PlanGrid Task Report - Jun 25, 2025

#29 [EXHA 506] [NEW] Exhaust fan discharge nozzle.

L05435_RELO - Polaris Parkway (OH) FSU

1515 Polaris Parkway, Columbus, Ohio

Sheet
M-501

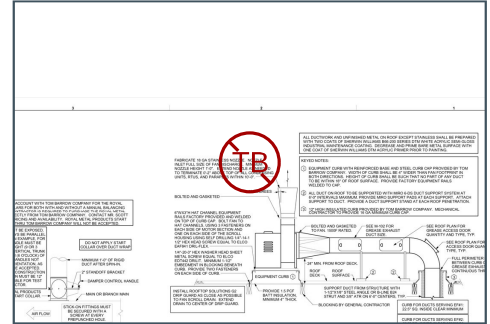
Exhaust Fan 2 nozzle does not reach at least 2" above nearest parapet wall, and will require an extension.

RETURN TRIP 6/25/25: EF2 NOZZEL DOES NOT EXTEND ABOVE PARAPET WALL.

Code reads if less than 10' must be extended. We are over 10' from nearest parapet wall extension is not required
